Green Life Knit Composite Ltd. (11061)

31.MARCH.2014

Discrepancy in 2-Storeyed Warehouse/Medical Clinic/Dining Area Drawings

Discrepancy in Drawings

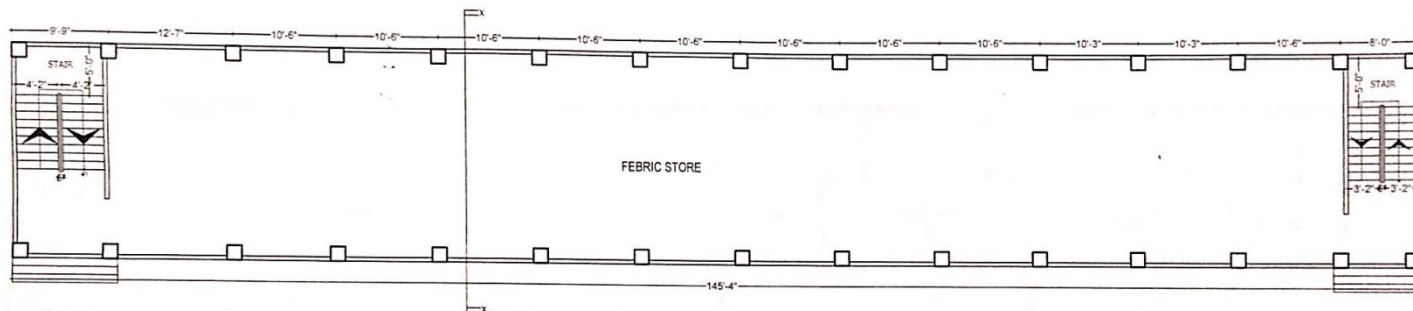
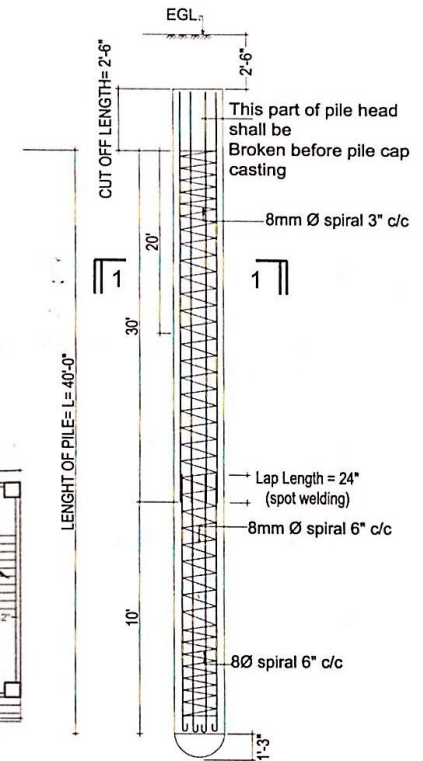
There is uncertainty as to whether the 2-storied Warehouse/Medical Clinic/Dining Hall building was intended to have a basement. Building sections show no basement and piles are shown starting 2'-6" below the existing grade level. However, there is a basement floor plan presented and there appears to be a beam and slab reinforcing plan for a suspended slab Ground Floor

ITEM 1: (Priority 2) There appears to be discrepancy in the both the Architectural and Structural drawings as to whether the 2-storied Warehouse/Medical Clinic/Dining Hall building is intended to have a basement.

Item No.	Observation	Recommended Action Plan	Recommended Timeline
1	There appears to be discrepancy in the both the Architectural and Structural drawings as to whether the 2-storied Warehouse/Medical Clinic/Dining Hall building is intended to have a basement.	Design engineer to comment as to the acceptability of the as-built structure.	6-weeks
2	There appears to be discrepancy in the both the Architectural and Structural drawings as to whether the 2-storied Warehouse/Medical Clinic/Dining Hall building is intended to have a basement.	Implement any recommendations of the design engineer.	6-months
3	Although storage loads were for the most part very reasonable, there was no apparent management of allowable floor loadings and some localized areas of higher than desirable loading were observed.	Develop and implement a formal loading plan for all floor plates within the factory giving consideration to slab, beam and column capacities.	6-weeks
